Project: Mt Welcome Subdivision
To: Incite

Project No. 310206500

Reference: Mt Welcome: TRANSPORT COMMENTS RESPONSE

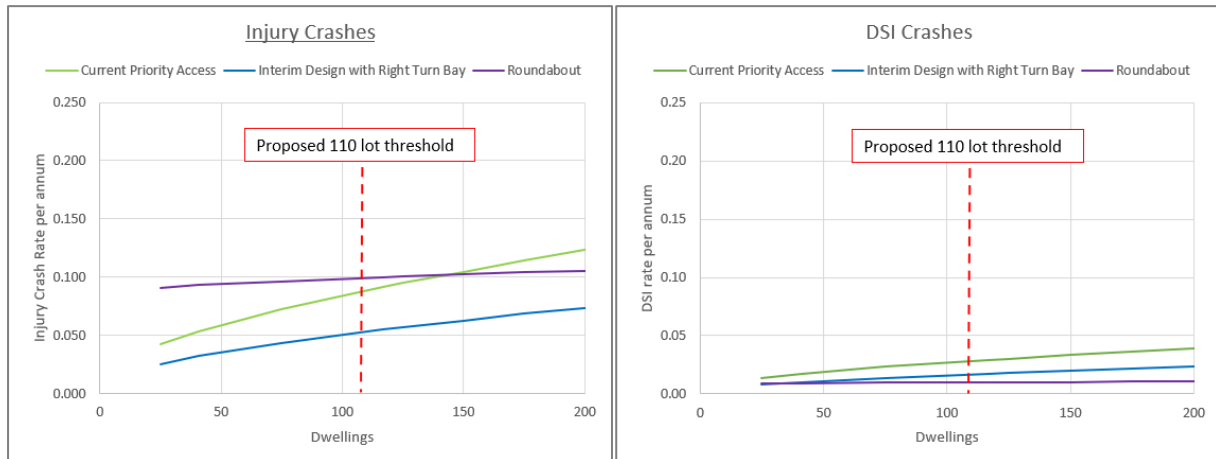
Further detail is requested on the analysis undertaken to inform the development threshold of 110 lots to be supported by the Interim Site Intersection arrangement – prior to the permanent intersection arrangement of a roundabout being delivered. Specifically, the following information is requested:

“NZTA requests that the developer demonstrate, from an overall safety risk perspective, how the 110-lot threshold has been determined and whether it represents the optimal point at which to upgrade the intersection from the interim to permanent intersection solution. In particular, the Applicant should provide:

- a. the predicted DSI crash rate for the 110 lots development threshold, and*
- b. a comparison of the total DSIs outcomes for both the interim priority T-intersection with RTB and permanent dual lane roundabout options at various development levels to identify the appropriate threshold.”*

The PPM guidance is understood to take account of both injury crashes and Death or Serious Injury crashes (DSI). The two graphs provided below have been generated using the same assumptions adopted in the ITA (Section 11) to illustrate the 'Injury Crash' rate and 'DSI' crash rate for a range of lots between 0 and 200, for each of the 'Current Priority Access' arrangement, the proposed 'Interim Right Turn Bay' design, and a 'Roundabout'. The proposed threshold of 110 lots drawn from the PPM guidance is illustrated on each graph, for reference.

Reading from the graphs, the proposed interim design with right turn bay (blue line) is the preferable layout with respect to injury crashes at the 110 lot threshold, and even beyond 200 lots. Whilst consideration of DSI crash rates alone suggests a roundabout begins to offer a marginal safety benefit at side road volumes equivalent to around 50 lots, adopting this threshold would imply that even relatively minor side roads and accesses connecting to State Highways should be controlled by roundabouts. That's simply not practicable or necessary. Notwithstanding this, the predicted crash risks at these traffic volumes remain very low, with the model indicating approximately one DSI crash every 100 years for a roundabout compared with one every 60 years for the interim right-turn bay treatment at the 110-lot threshold. Accordingly, having regard to the PPM guidance, the relatively small difference in predicted crash risk, and the limited duration for which the interim intersection would operate prior to construction of the roundabout, the proposed 110-lot threshold remains appropriate.
